Docket Item # 3
BAR CASE # 2010-0129

BAR Meeting
June 23, 2010

ISSUE: New Construction
APPLICANT: Amir H. Motlagh by Level 10 Properties
LOCATION: 626 North Patrick Street
ZONE: RB/Residential

The applicant is requesting **Concept Approval** for the construction of a new townhouse at 626 North Patrick Street prior to making an application for a special use permit.

Figure 2. Existing and proposed streetscapes.

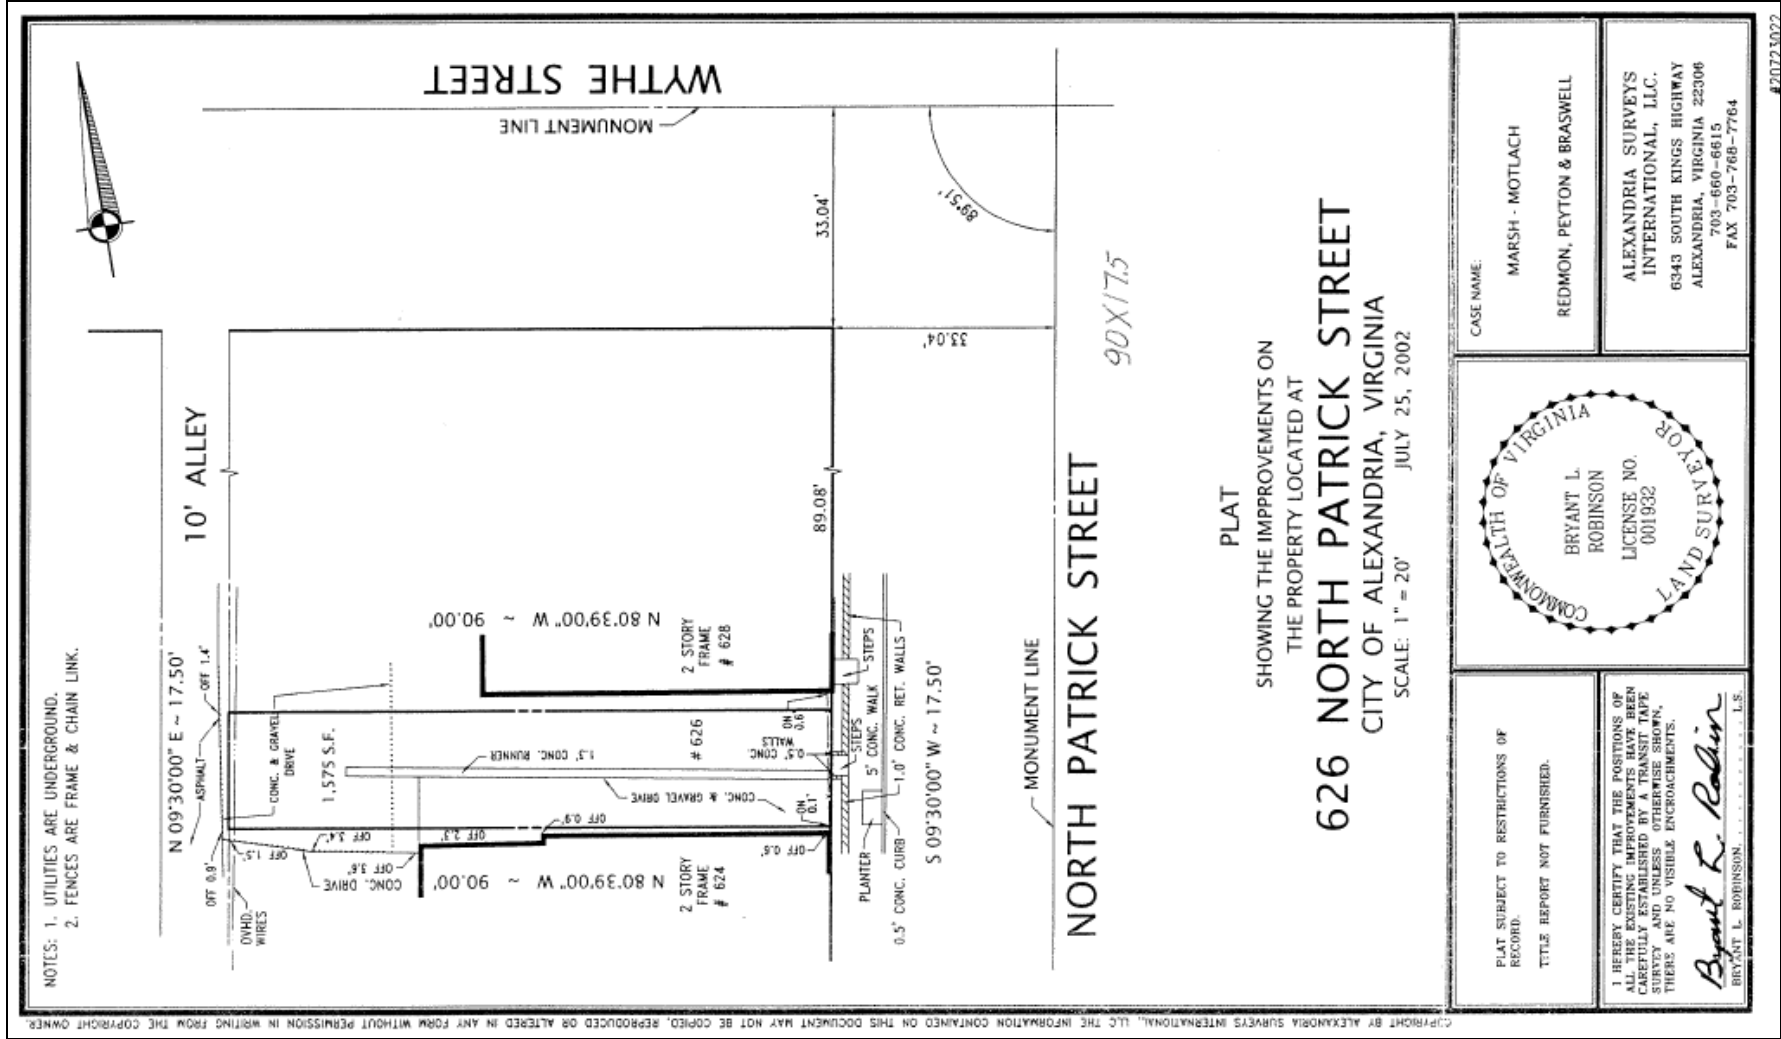
Staff recommends concept approval of the proposed infill townhouse with a Greek Revival architectural vocabulary, noting it will enhance the streetscape along the 600 block of North

Patrick Street. The applicant looked at existing properties in the historic district, as well as current development patterns, in an effort to achieve a historically appropriate scale, mass, and proportion. Although the townhouse will be taller than the adjacent historic townhouses, its scale and massing are compatible to the existing buildings and will serve to fill in a void along this blockface. The west side of the 600 block of North Patrick has a series of set-back brick townhouses, built circa 1980, in the southern portion. Immediately adjacent to the subject property are two-story, two-bay freestanding frame townhouses. At the northwest corner of this block is the Church of God, a frame, gable-fronted church, which recently received approval for a substantial addition (BAR Case # 2009-0273). On the east side of the street are a series of small stucco apartment buildings from the 1950s that are owned and maintained by ARHA.

Figure 6. Perspectives from street.

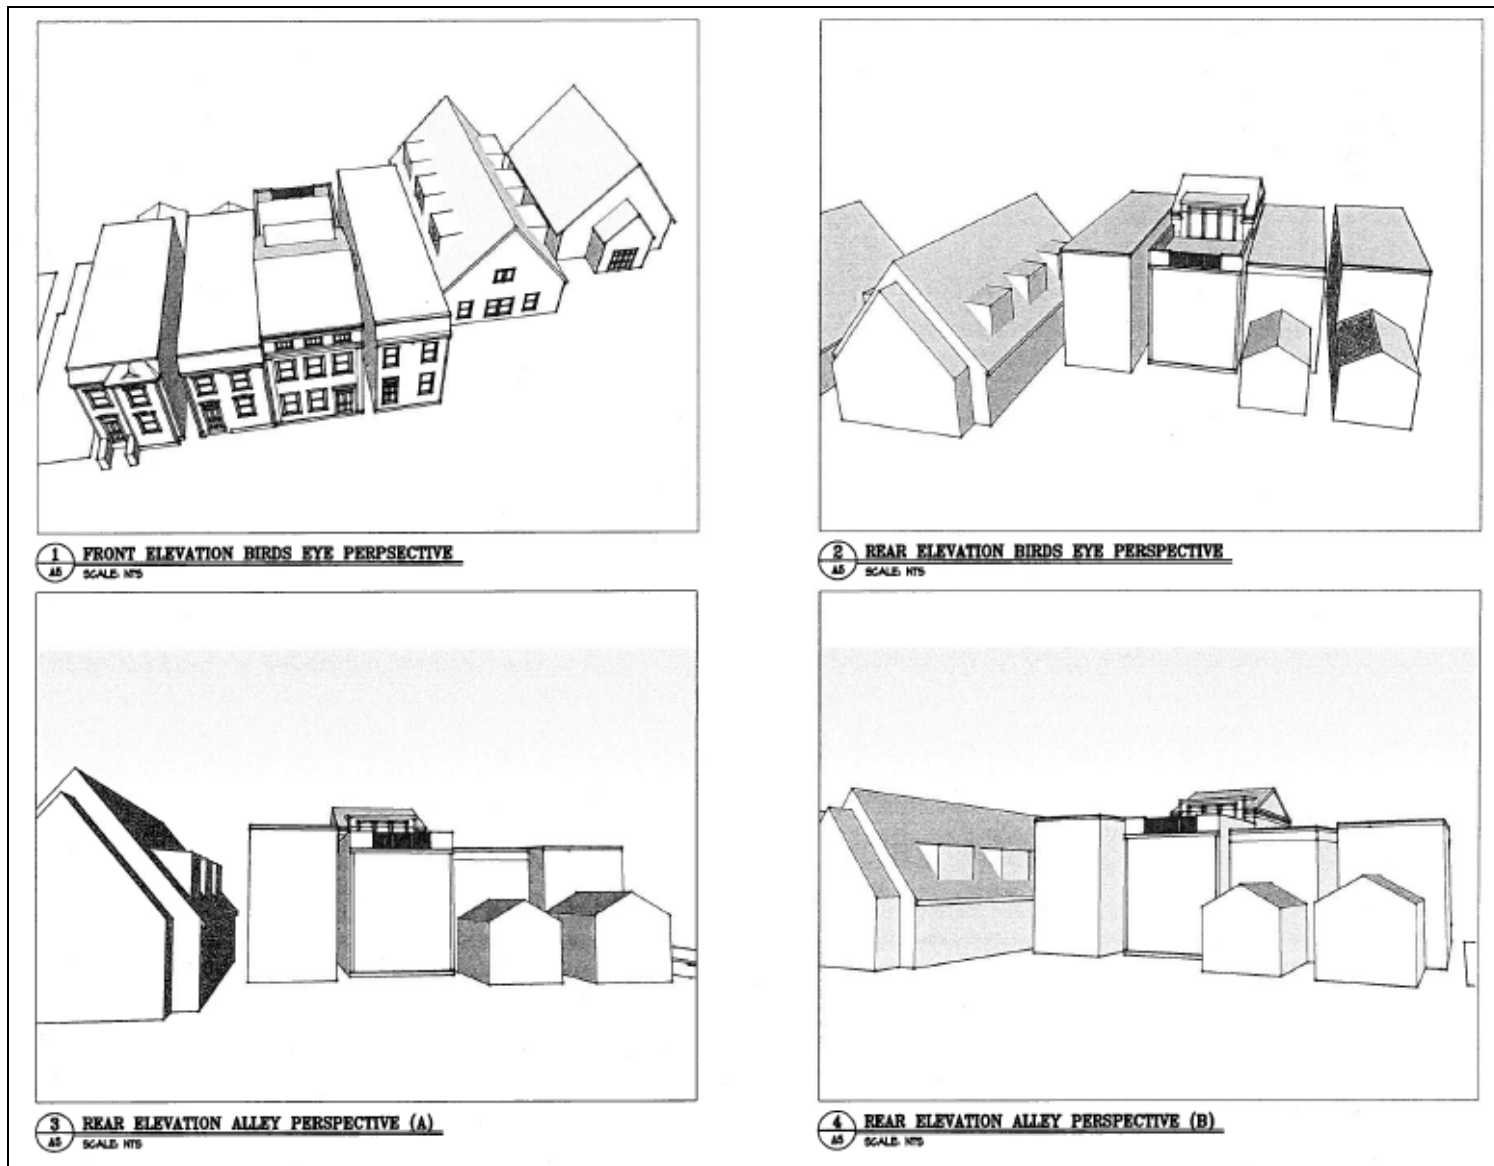
The application did not include side elevations as these elevations are on the property line and cannot have any openings. The perspective drawing illustrates the side gable form. The south elevation will not be visible and the north elevation will be minimally visible.

Staff believes that the proposed townhouse complies with the *Design Guidelines* for new construction and is appropriate in terms of size, massing, and architectural character. The *Guidelines* specifically state that "...the Boards seek to promote compatible development that is, at once, both responsive to the needs and tastes of the late 20th century while still being compatible with the historic character of the districts." Staff believes that the proposed townhouse meets this goal, taking design elements from historic buildings and incorporating them into new construction. Further, the massing and scale are appropriate to the surrounding buildings as well as to the district as a whole. The use of the attic story with windows in the frieze, effectively allows for a useable third story while not overwhelming the adjacent historic buildings. The three townhouses immediately to the south have an interesting configuration each with a one-story attached garage at the rear. The proposed townhouse does not extend as far to the rear as these three dwellings. While the *Design Guidelines* state the "Boards have expressed serious reservations regarding the appropriateness of roof decks on structures in the historic district," Staff finds the proposed roof deck to be well-designed and notes that it will be minimally visible.
